# 1013 NE 45TH STREET

SDCI # 3037927-EG | MUP # 3037792-LU

RECOMMENDATION MEETING

03.28.2022

## 2. MASSING

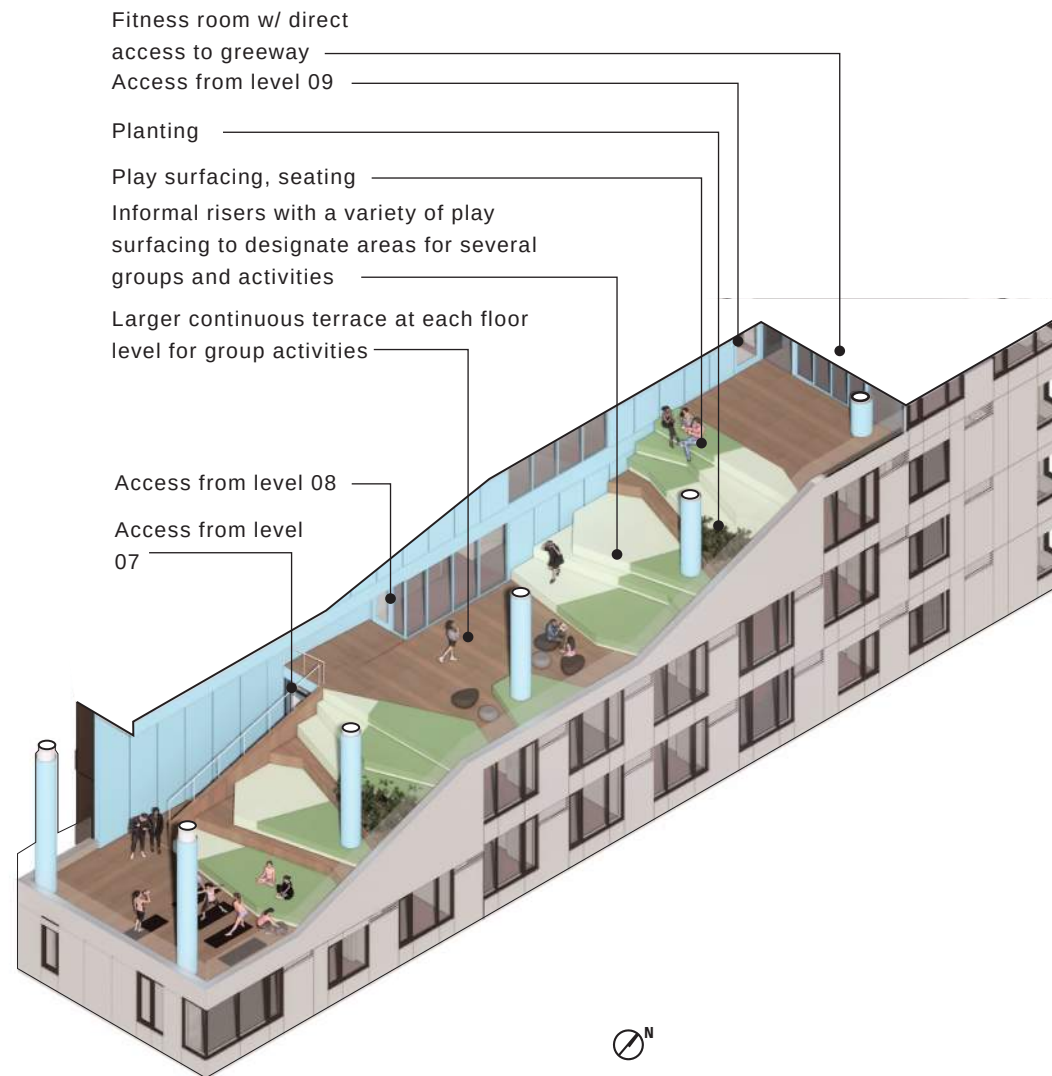
d. There was some discussion and appreciation for the consistent height of the carved- out amenity space as shown in Option 2, however, the Board remained supportive of Option 3. **The Board did note that more information on the programming and how the amenity spaces are intended to be used would be helpful at the next meeting.** (DC2-1 Massing & Reducing Bulk and Scale)

+ The Board supported Option 3 has been further developed and the carved amenity area design has progressed. On the left is a diagram showing the programming of the indoor and outdoor amenity spaces which includes the social greenway carved terraces on the east and west facades. The lower or "mid-rise social greenway" facing east has a focus toward active fitness and wellness uses while the west facing "high-rise greenway" provides for more relaxing socialization, views of the water, the City skyline and afternoon sunlight. (Please the following page for additional information regarding the programming development of the social greenways.)

## 2. MASSING

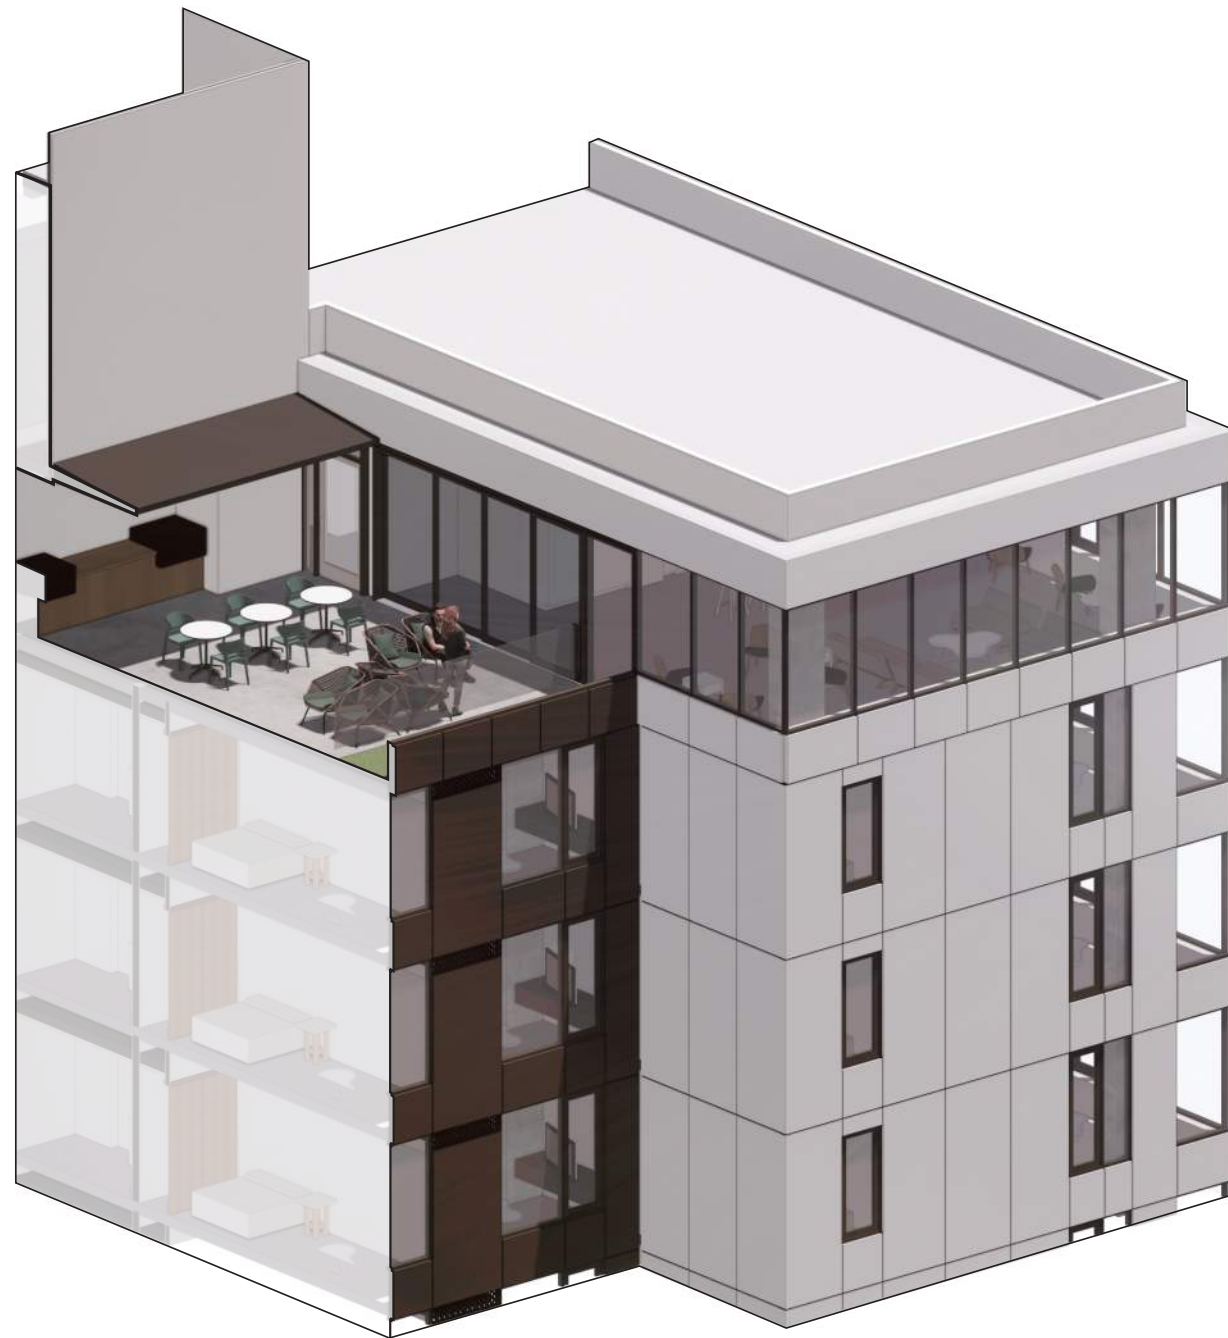
e. The Board supported the general form of the tower terminus which continued the simple form, but questioned how the carving language could potentially inform the tower terminus. **This was not a direct request to study, rather guidance to clarify the terminus design intent at the next meeting and ensure the final design of the terminus added to the compelling design concept.** (University DC2-6 Tall Building)

### DESIGN RESPONSE

## EDG RESPONSE | STREET EDGES & OPEN SPACES COMPARISON

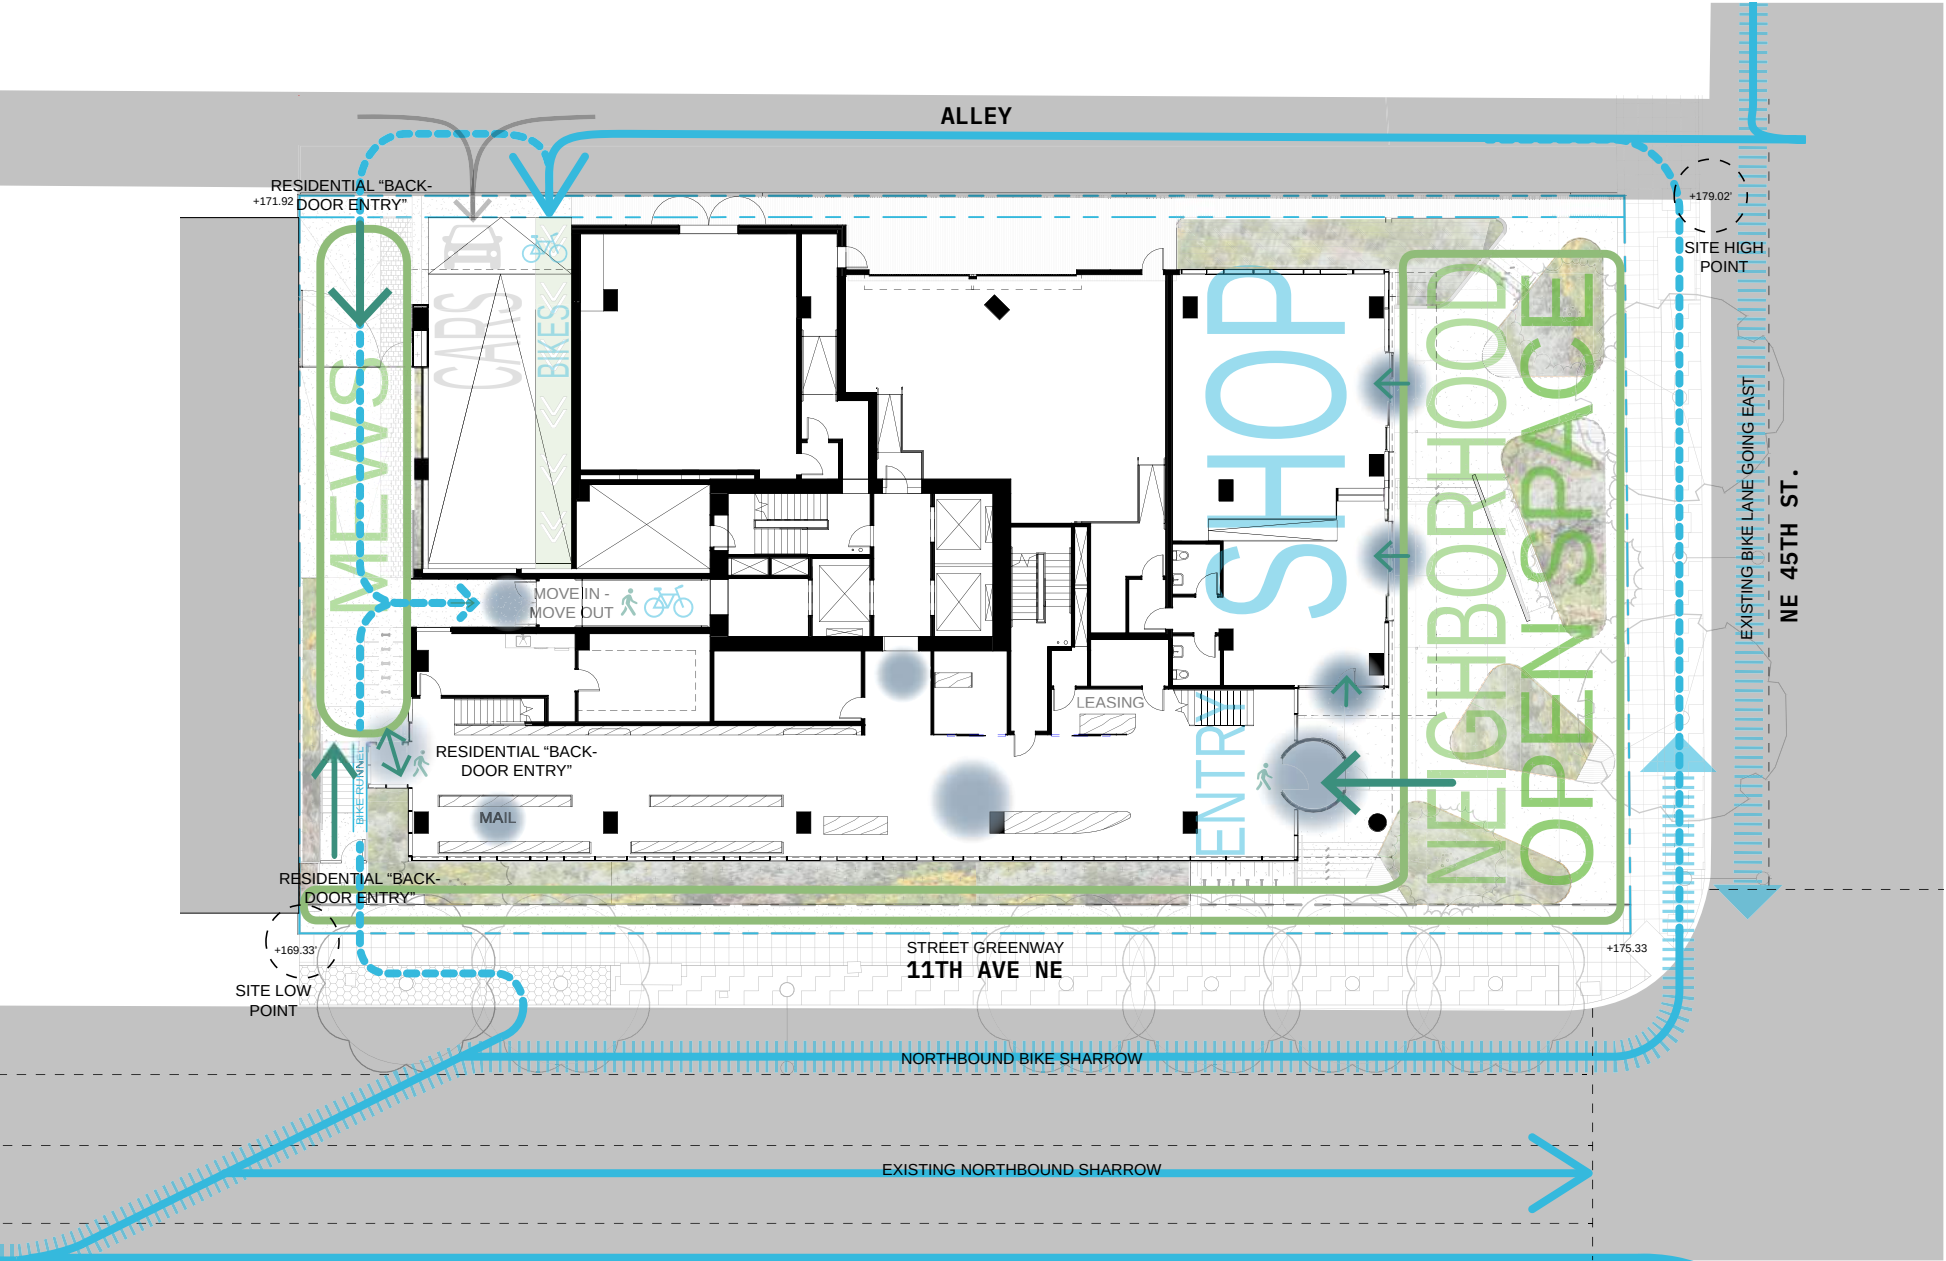
a. Overall, the Board supported the street-level programming and organization of uses, as well as the open space concept at street-level. (PL1-A Network of Open Spaces, PL1-1-a. Engage the Public Realm)

b. The Board acknowledged that 45th Ave is a highly trafficked street and not currently particularly pedestrian friendly along north edge of the project, and appreciated efforts made to highly landscape this edge. (DC1-1 Activating Uses)

c. The Board would like to see additional development and clarity along the 45th Ave street edge including the following (PL1-A Network of Open Spaces, PL1-1-a. Engage the Public Realm, DC1-1 Activating Uses, DC2-B-1. Façade Composition):

- i. Maintaining and/or increasing the landscaping
- ii. Consideration of carving out the massing along this street-level to relate back to the upper tower. Though the Board acknowledged the specialness of having this gesture occur at one location, they noted they would like to see interesting treatment of the landscape/hardscape equal to what is happening above. No specific direction was provided, rather to further flush out the concept at street-level and refine the architecture and landscape as needed to achieve this goal.

### DESIGN RESPONSE

+ The landscaping along NE 45th Street has been refined to allow for more porosity along the street while added more softscape plantings and site features within the neighborhood open space. (Please see p. 42 for additional information)

+ The organic / curvilinear shape of the site elements reflect the theme of the social greenway spaces in the tower. The plantings and site features contrast with the "rational street edges bordering the site (Please see p. 42 for additional information)

3. STREET EDGES & OPEN SPACE

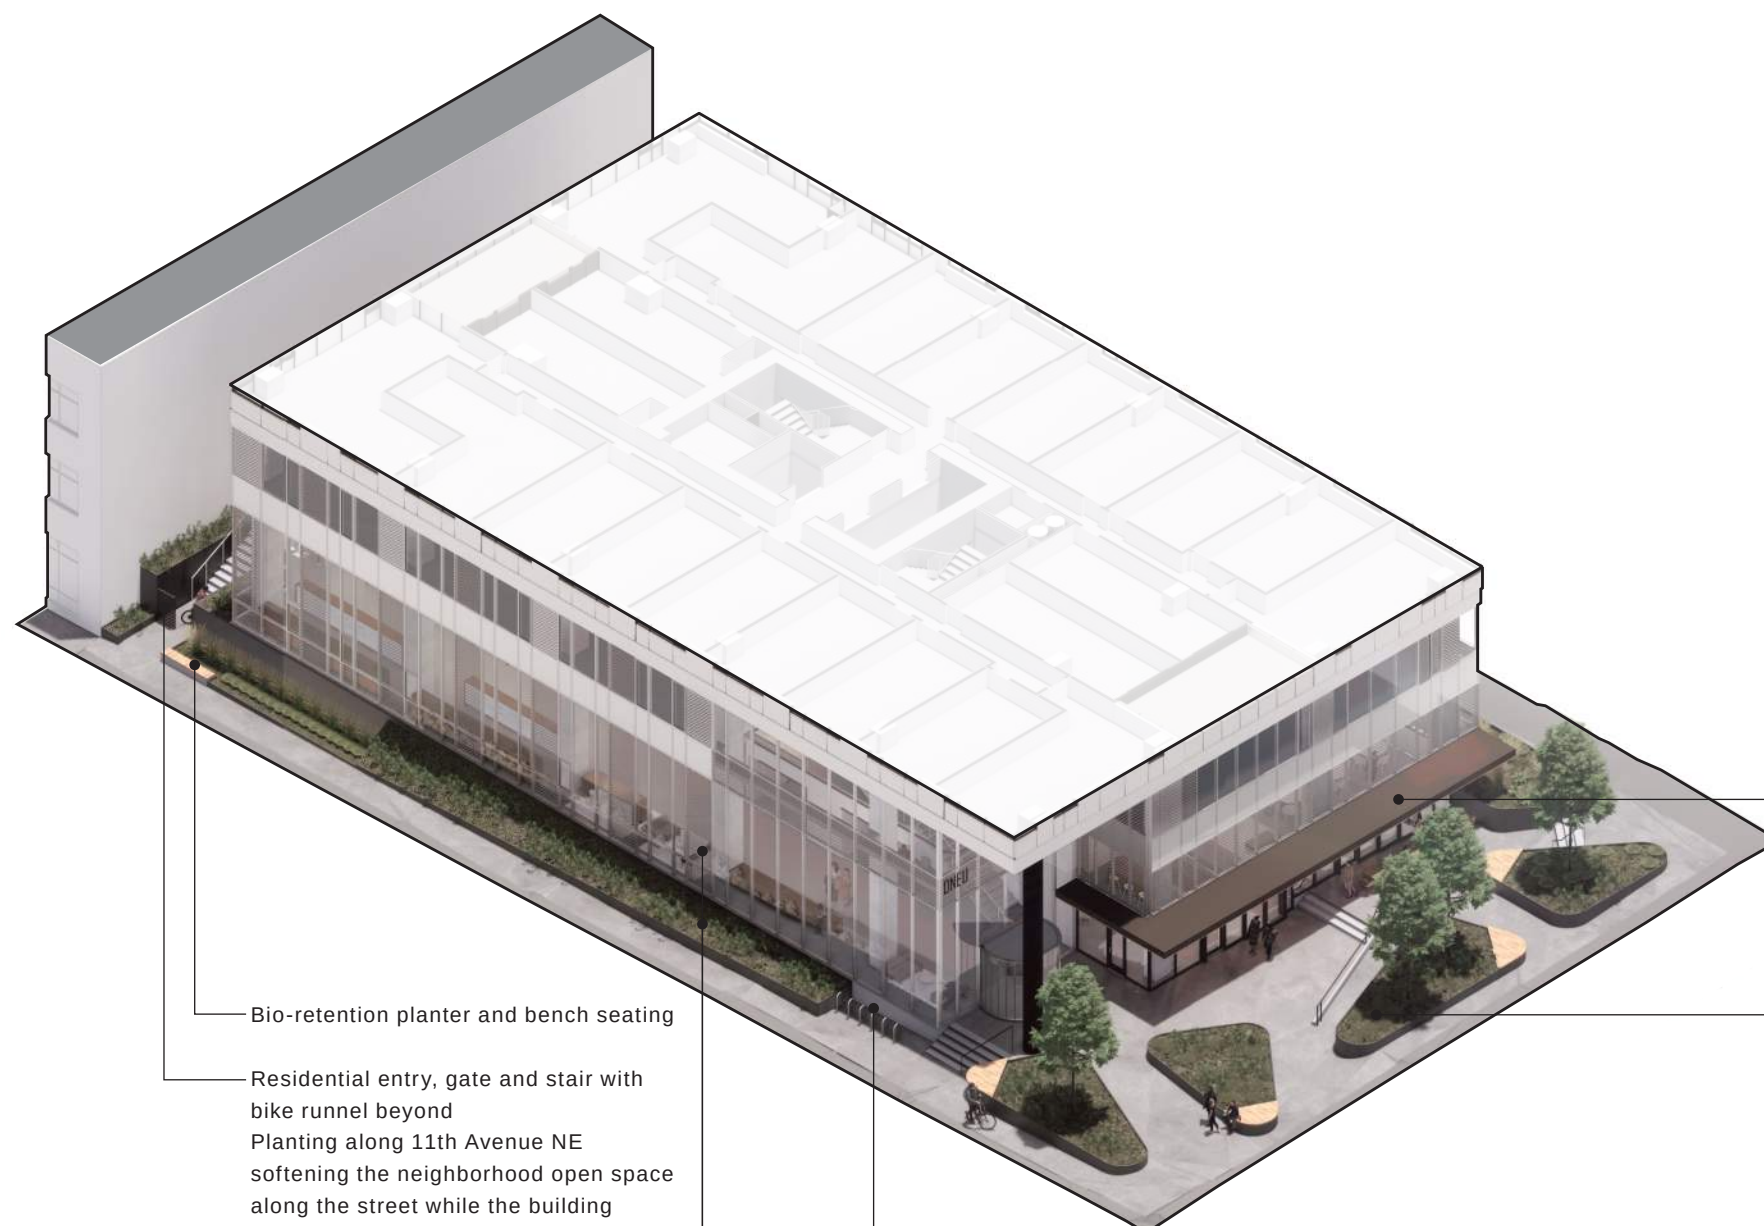
c. The Board would like to see additional development and clarity along the 45th Ave street edge including the following (PL1-A Network of Open Spaces, PL1-1-a. Engage the Public Realm, DC1-1 Activating Uses, DC2-B-1. Façade Composition):

- i. Maintaining and/or increasing the landscaping
- ii. Consideration of carving out the massing along this street-level to relate back to the upper tower. Though the Board acknowledged the specialness of having this gesture occur at one location, they noted they would like to see interesting treatment of the landscape/hardscape equal to what is happening above. No specific direction was provided, rather to further flush out the concept at street-level and refine the architecture and landscape as needed to achieve this goal.

DESIGN RESPONSE

+ The diagram of the site plan to the left outlines building and site uses, vehicular and pedestrian access and entry points into the building. Site features include bicycle parking at the tower entry. The residential "mews" serves as a second means of access for residents. The area would be secure with gates (please see pp. 51-53 for addition information.) The mews would also allow for on site move-in/out functions and deliveries during business hours. Access to a package room and building management space is adjacent to the mews. A bike runnel is added to the stair at the southeast corner of the site for residents.

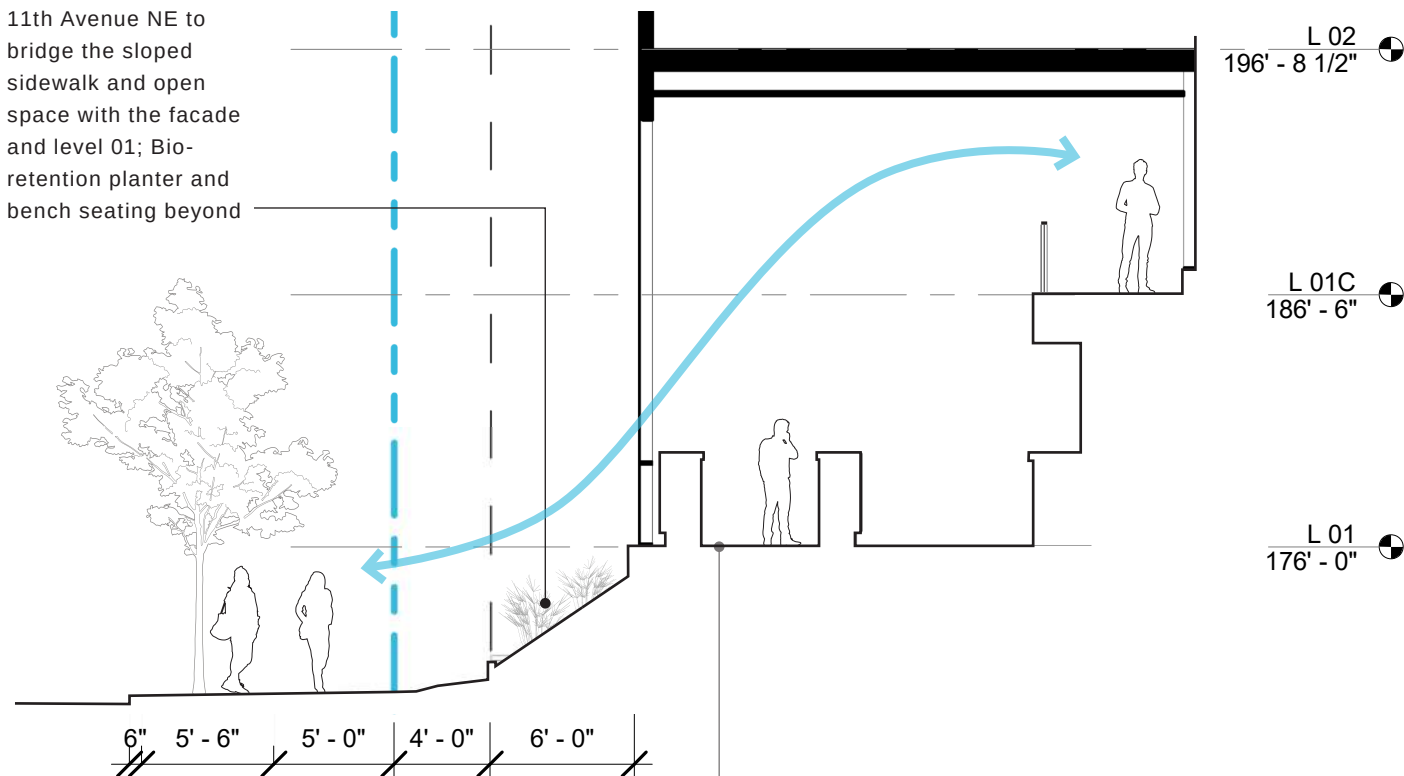
d. The Board supported the 11th Ave street-level landscape and questioned if the overhead weather protection was needed along this street edge. **The Board commented they would be open to a departure along this east edge of the project as the north edge was the public / civic edge while the east edge was the quieter less trafficked edge.** (University DC2-2 Architectural Concept & Façade Composition)

DESIGN RESPONSE

+ The 11th Avenue facade is clad in transparent glass rather than the tinted glass of the residential uses beginning on level 03. Above the street level on level 02 are offices. The transparent, spandrels and patterned glass follows the solid / void grid concept above but starts to "dematerialize" at level 02 and further becomes more transparent at the street level. This is done to acknowledge the different uses and to accommodate more active and open street fronts. At the entry notch is a double height lobby space providing views into the building and up to the office space on level 02. The building program at the street are intended to relate to the figural elements proposed as site furniture and plantings along the street.
